Access Compliance Report

Public Rights-of-Way

(Curb Ramps)

Intersection ID: 12269	Main Street: E_10TH_ST	Cross Street: N_DAVIDSON_ST	Location: W
ADA ID: 62D89FB47C7A	Ramp Type: Perp	Initial Pass/Fail: Fail	Overall Compliance: No
Severity Score: 12.5			
Codes/Mitigation Info/Possible Solution		Field Measurements/Component Compliance

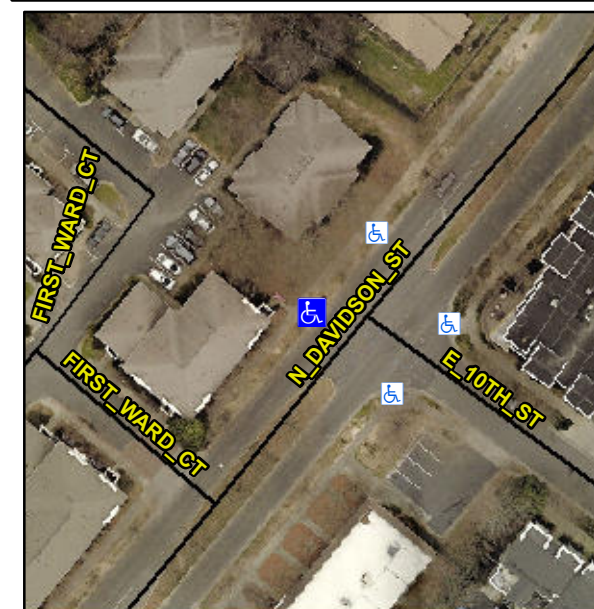
Not Found, R304.2.2

Compliance	Description	Data	Compliance	Description	Data
N/A	Ramp Length (in)	80.0	No	Ramp Slope (%)	9.1
Yes	Ramp Width (in)	48.0	Yes	Ramp XSlope (%)	0.9
N/A	Flare Type LT	N/A	N/A	Flare Type RT	N/A
N/A	Flare Slope LT (%)	N/A	N/A	Flare Slope RT (%)	N/A
N/A	Flare Traversable LT?	N/A	N/A	Flare Traversable RT?	N/A
N/A	Landing Length (in)	N/A	N/A	DWS Provided?	N/A
N/A	Landing Width (in)	N/A	N/A	DWS Contrast?	N/A
N/A	Landing Slope (%)	N/A	N/A	DWS Length (in)	N/A
N/A	Landing X Slope (%)	N/A	N/A	DWS Full Width?	N/A
N/A	Landing Curb? (Y/N)	N/A	N/A	DWS Offset (in)	N/A
N/A	Shared Landing?	N/A			
N/A	Gutter Ponding?	N/A	N/A	Gutter Slope (%)	N/A
N/A	Gutter Lip Ht (in)	N/A	N/A	Gutter X Slope (%)	N/A
N/A	Painted X Walk1?	No	N/A	Painted X Walk2?	N/A
	X Walk 1 Direction	To SE		X Walk 2 Direction	N/A
N/A	X Walk 1 Width (in)	N/A	N/A	X Walk 2 Width (in)	N/A
	X Walk 1 Slope (%)	3.5		X Walk 2 Slope (%)	N/A
	X Walk 1 X Slope (%)	1.7		X Walk 2 X Slope (%)	N/A

Remove & Replace Entire Ramp.
